City of Tualatin

Attachment H2:

Public Comment Record 2015

<17713 - South Tualatin Neighborhood Diagram_08-18.pdf>

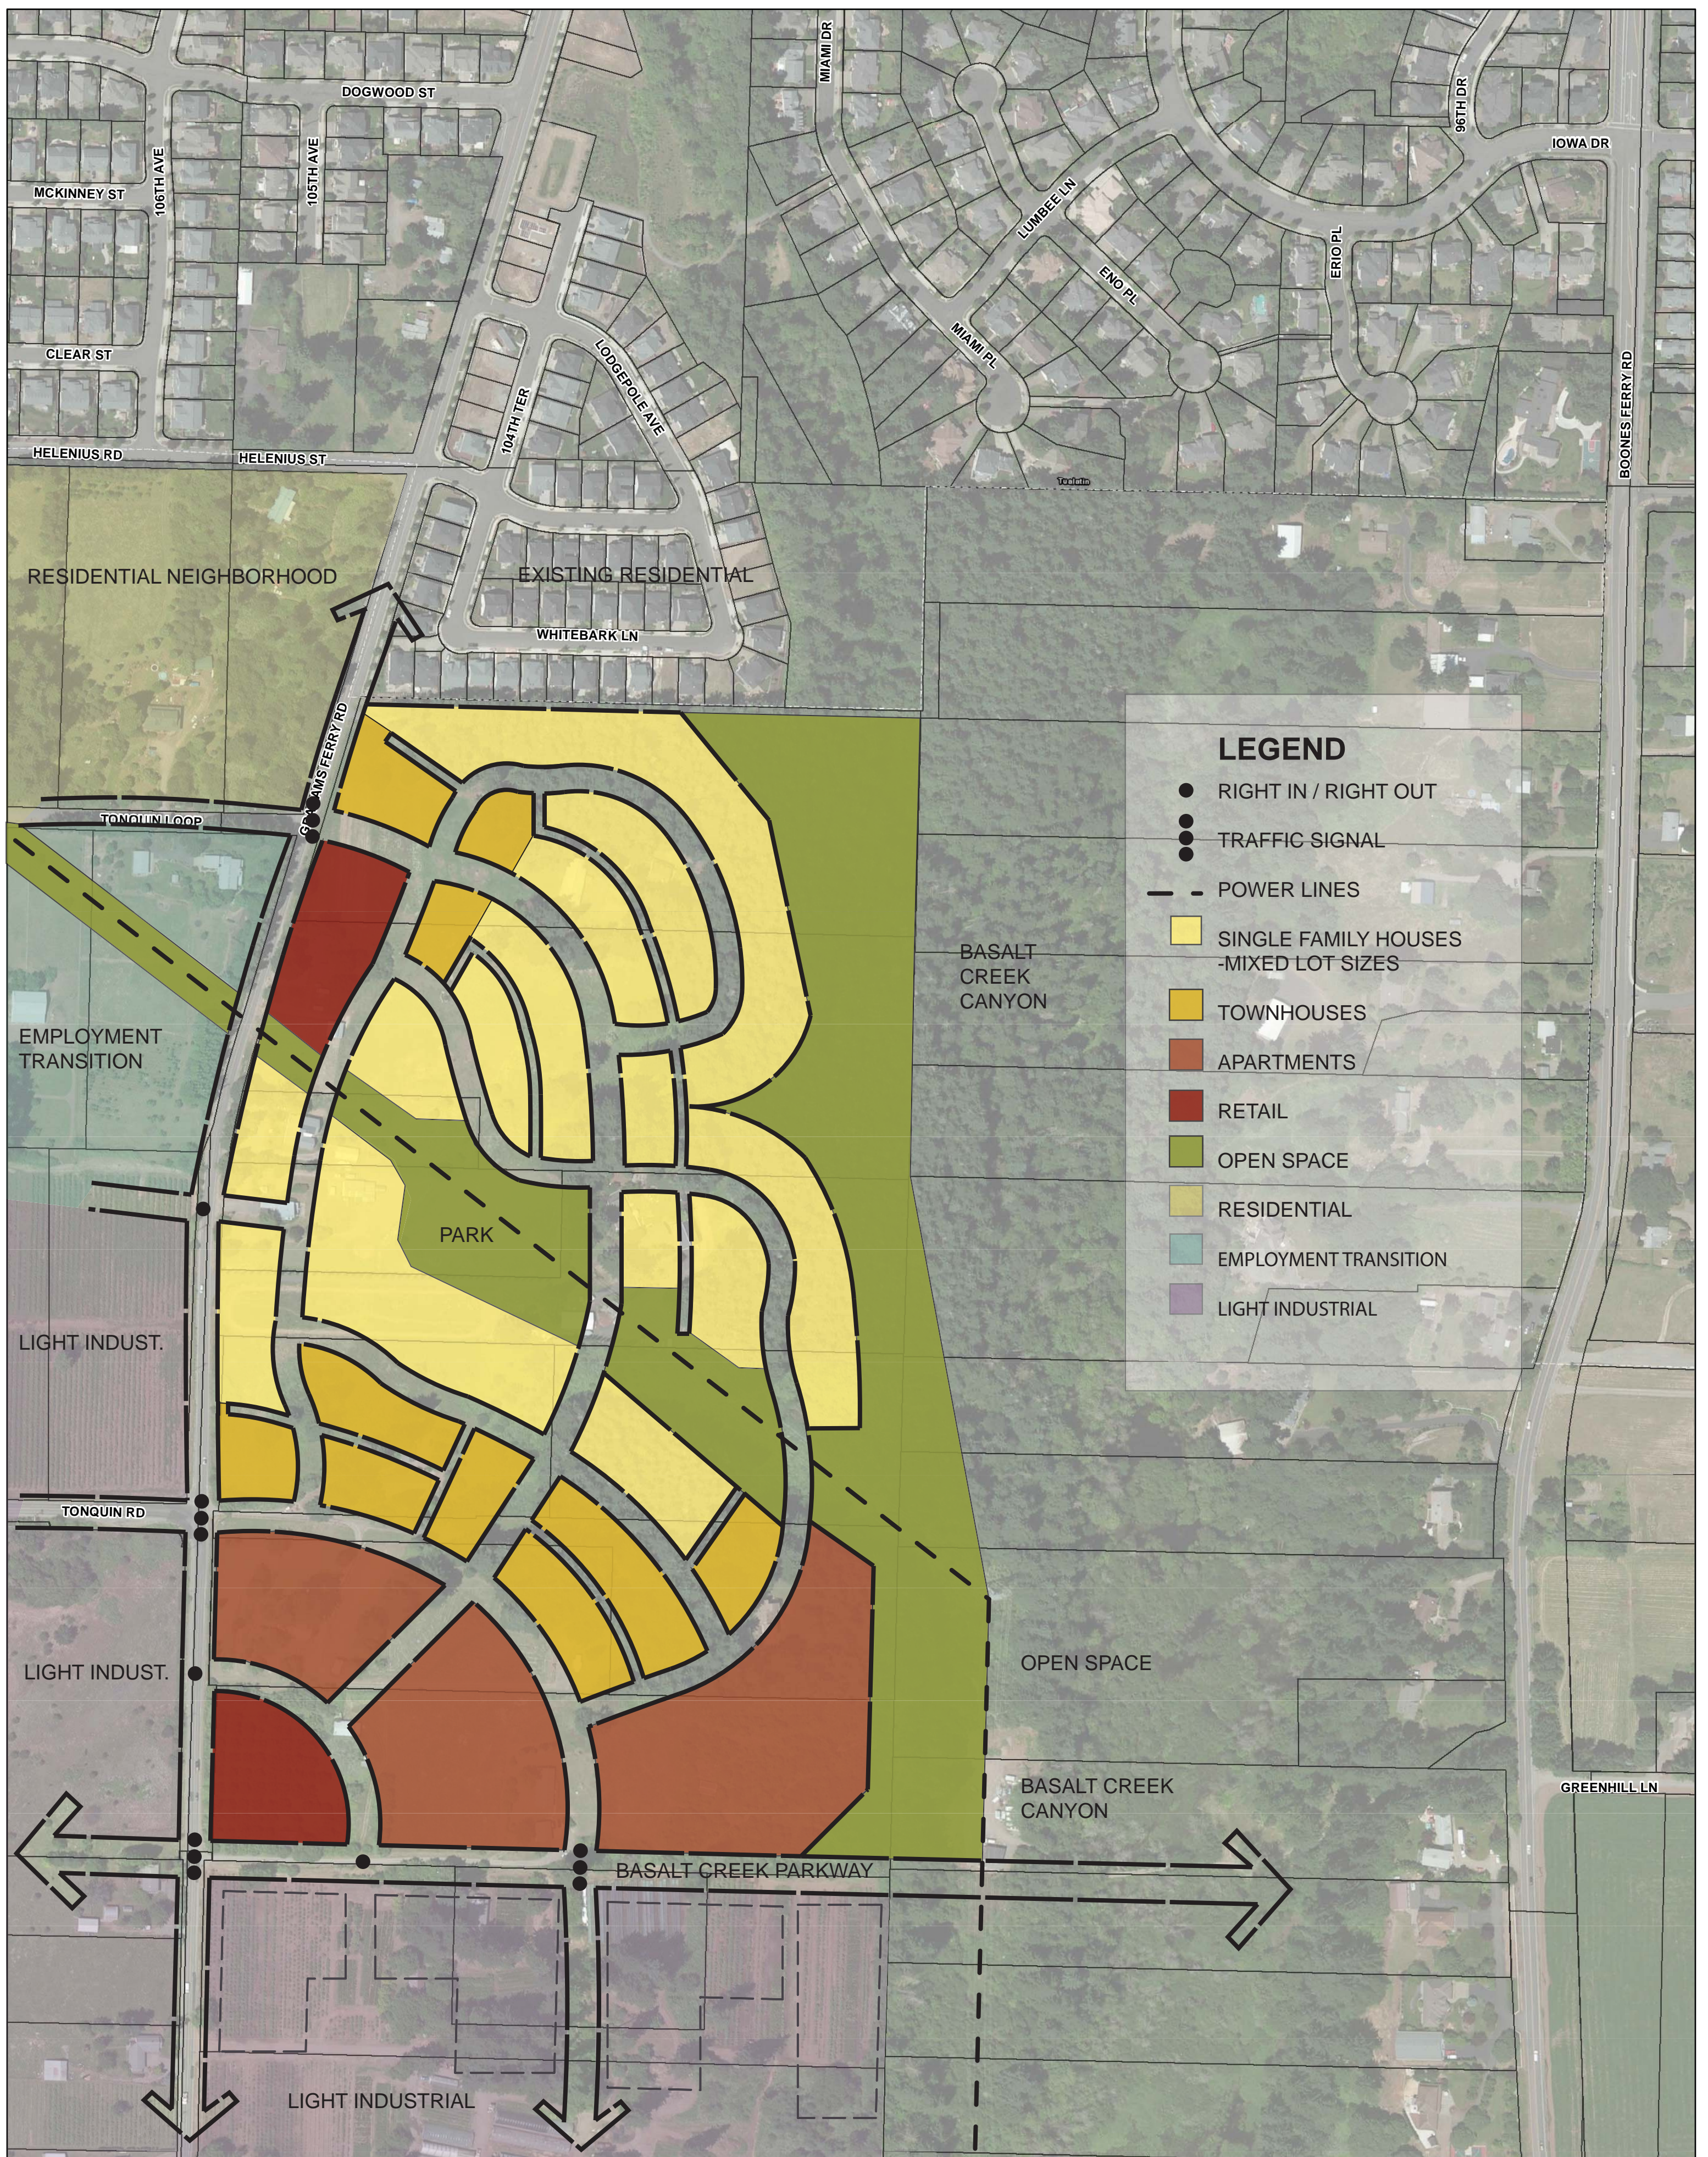
The plan that Otak produced for me shows a small retail center at both the intersection of Tonquin and Graham's Ferry and the intersection of Graham's Ferry and the new Parkway (the extension of 124th).

Otak's plan connects to the existing housing in Tualatin with a parkway in the power line corridor. As I mentioned in the email, with the plan attachments, the land shown in Otak's plan is better suited for housing than light industrial because of the existing grades. If I have misunderstood the transportation plan I would appreciate staff commenting on this.

Hi Herb. Where you say your land is the NE Corner of Graham's Ferry and 124th I am confused. As I understand the plan is for 124th to extend south and intersect Tonquin in phase 1. In phase 2 124th will extend a bit farther south the new "Basalt Creek Pkwy". I don't know that 124th intersects Graham's Ferry??

Thanks for the email Lou. As you are aware I really hope that Tualatin is the city that will annex the land that we own and the plan that I submitted is utilized. Thanks for sending me the email which allowed me to clarify the location.

From: [Herb Koss](#)
To: [Cindy Hahn](#)
Date: Friday, September 11, 2015 3:25:15 PM
Attachments: [17713 - South Tualatin Neighborhood -Option 4 09-09-15.pdf](#)

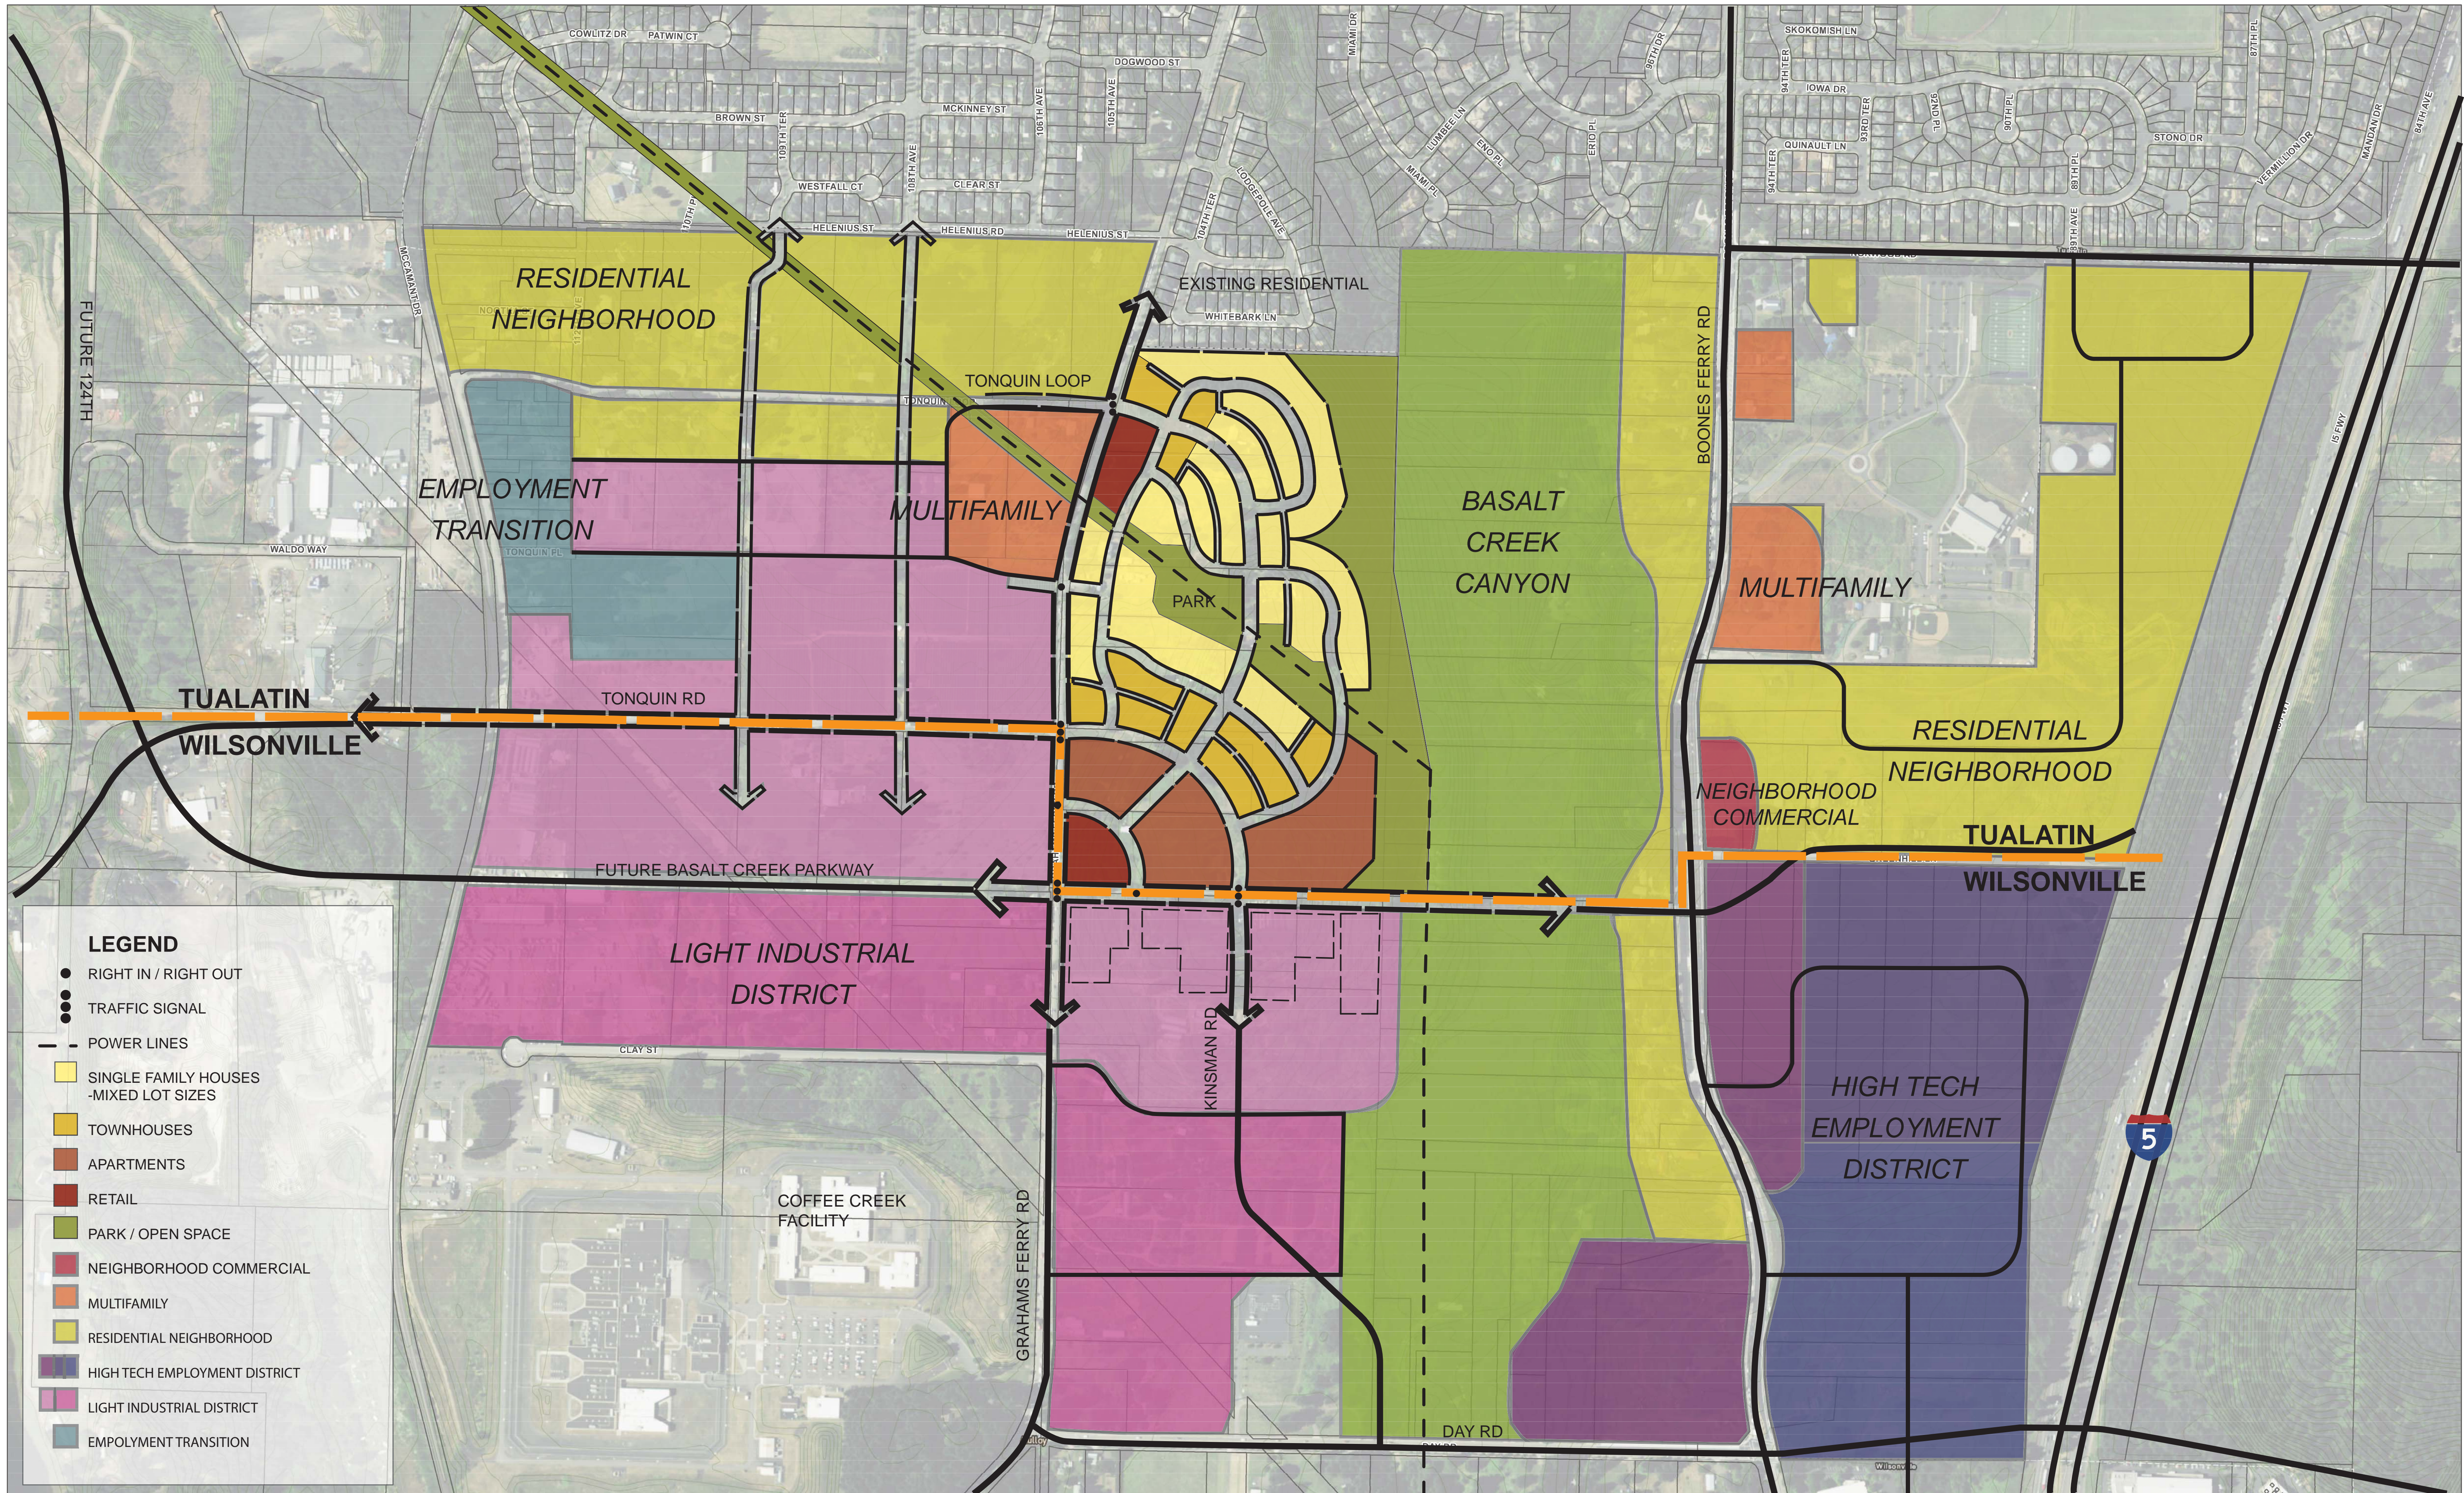
The topography of the site illustrated by the Otak plan utilizes the sloped topography. A visit to the Basalt Creek Planning area and viewing the land from Tonquin Road from West to the East clearly shows that a housing zone is a much better use of the land. Residential land uses are shown on the Otak plan where there is more varied topography because a residential use can be easily adapted to the slopes. Employment/Light Industrial Land uses require fairly level ground to accommodate large flat buildings and site improvements that can accommodate truck loading and circulation.

Two retail pockets are shown in locations that are easy to walk to for both residents and workers in the district.

The power line happens to be an amenity for pedestrians and bikers and is connected to the Basalt Creek Canyon, which will include bike and pedestrian trails.

I believe that the city boundaries shown are logical--- along collector streets with a clear delineation. Both cities get a fair balance of land. Wilsonville benefits from the High Tech Zoning and Tualatin benefits from a modest increase in Light Industrial Zoning to Tonquin Road.

STORM OUTFALL #5 PLAN AND PROFILE

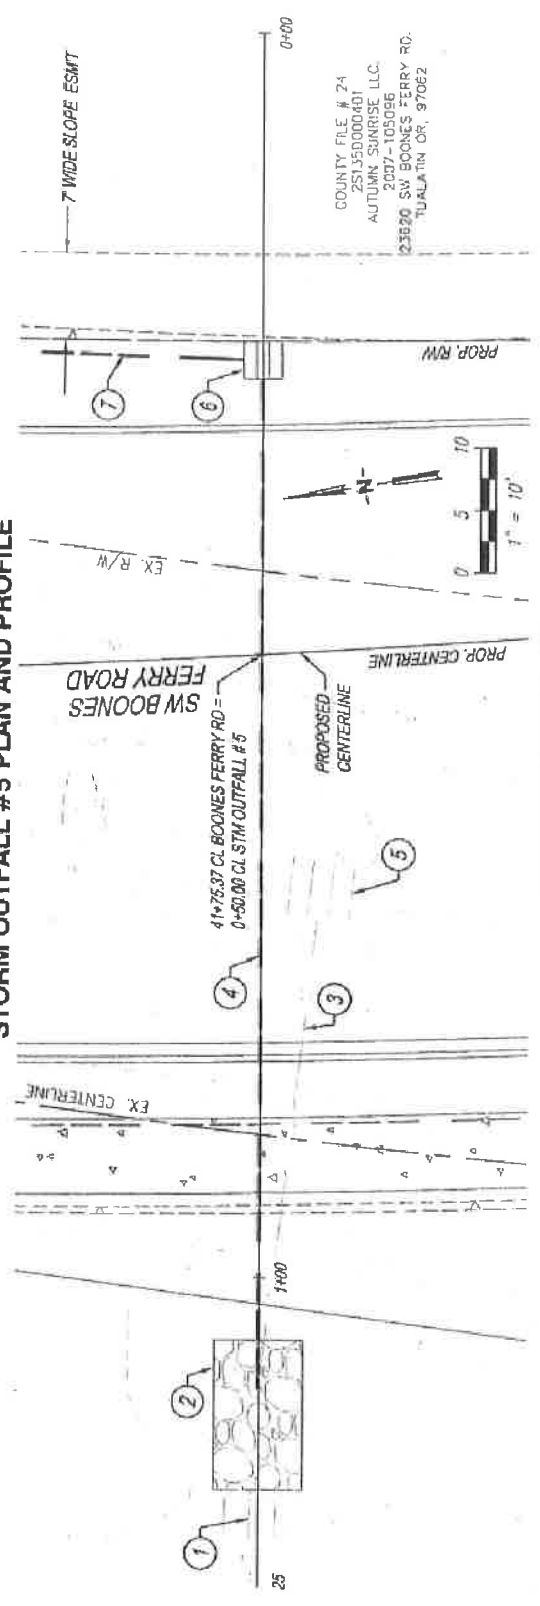
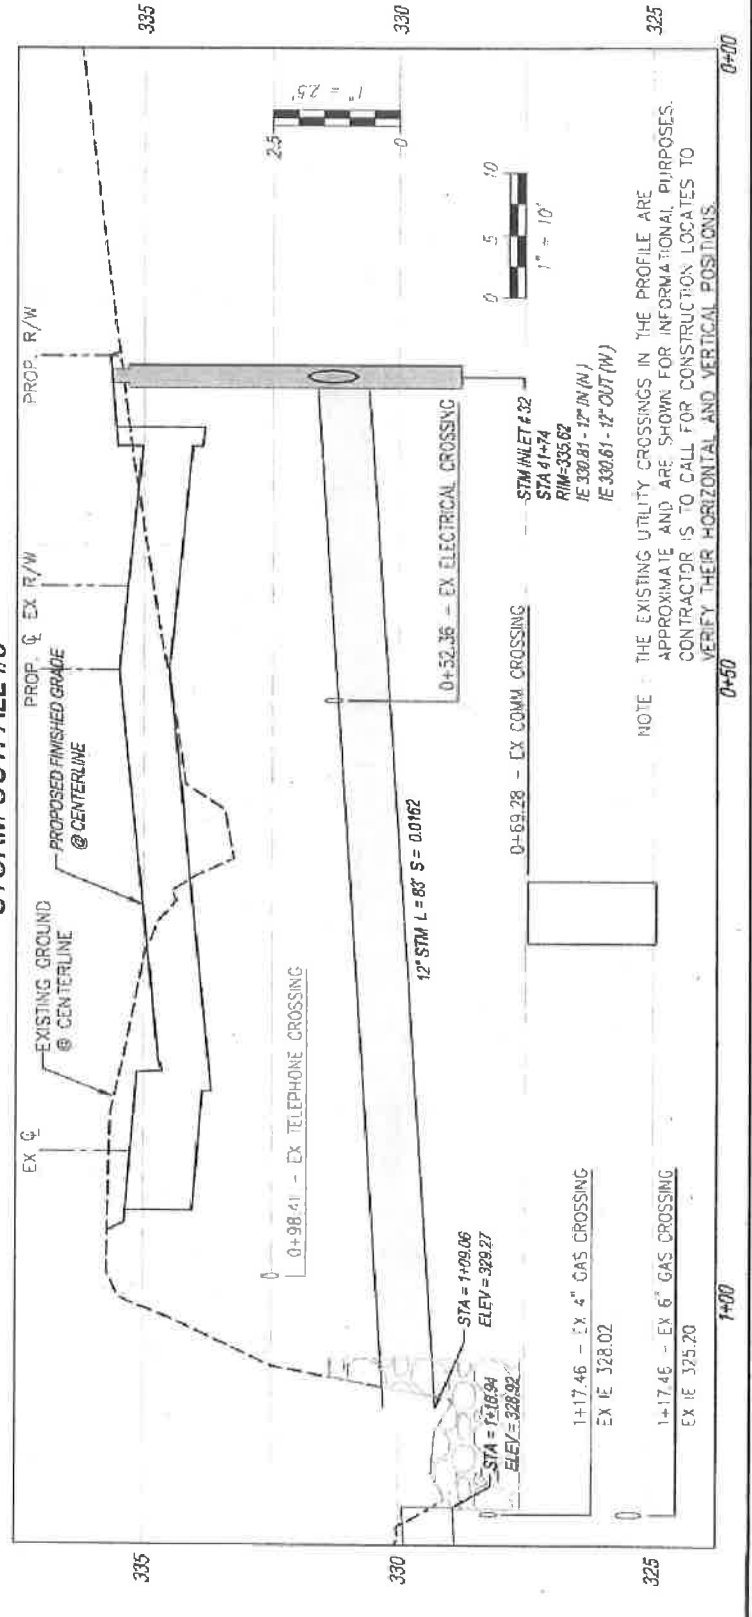
b) *Loss of Natural and Previously Existing Upstream Detention.* This can be seen when comparing previously existing ground elevations with final ground elevations shown in County's 100 percent complete Drawing Sheet 24A in Appendix D.²³ Natural and historical storm water detention and storage in the upstream subbasin have been substantially reduced by about 72 percent in this profile section alone.

³³ See Sheet No.179 of 274 of the 100 percent drawings, this is drawing labeled 24A – Storm Outfall #5: Plan and Profile. The headwater (HW) for the new culvert design is top of catch basin (CB) elevation 335.62 feet minus the culvert pipe invert elevation of 330.61, which equals 5.01 feet. Thus, the HW/D ratio is 5.01 for the 1-foot diameter (D) culvert pipe. That is a 5 to 1 ratio.

Natural and historical storm water detention and storage in the upstream subbasin have been drastically reduced. Storm water flows that once slowly found their way from the adjacent subbasin onto the Boones Ferry Road alignment are now excluded, by the fill from the widened roadway, and are routed directly into the culvert draining to the property. Comparing the previously existing ground elevations with the final ground elevations. See Drawing Sheet 24A that is the Plan and Profile for Storm Outfall #5.³⁷

For the proposed condition subbasin 59S shown on Sheet HYD2, the proposed and now constructed 83-foot long 12-inch diameter culvert is over twice the length of the original pipe intended to drain through the property. The altered culvert (55L in Sheet HYD2) that drains subbasin 59S has expanded inlet flow capacity as exhibited by the two new catch basins identified and shown on Drawing Sheet 24A in Appendix D.⁴⁰
